45P LG3 Detroit Assurance on Cummins X15

Campaign SF724

Published: 8/27/2025

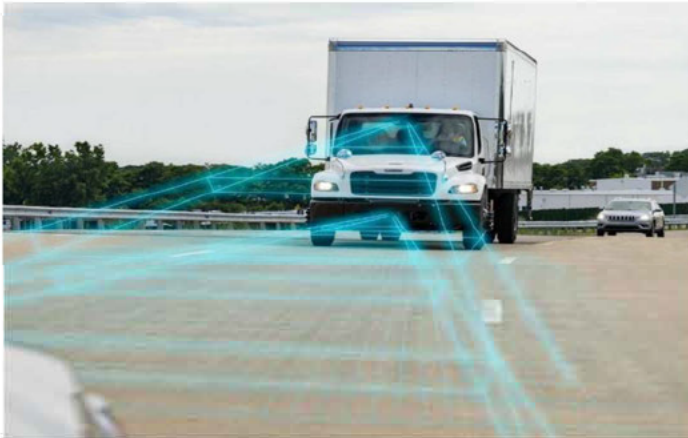
- Truck does not have ACC or TGW due to Cummins software delay
- Customers have ordered the ACC and TGW options in the Detroit assurance driver assistance system.

- Everything past February 15th has the updated 0.19 software

- Active field campaign to reflash the Cummins ECU, VRDU, CGW, ICUC
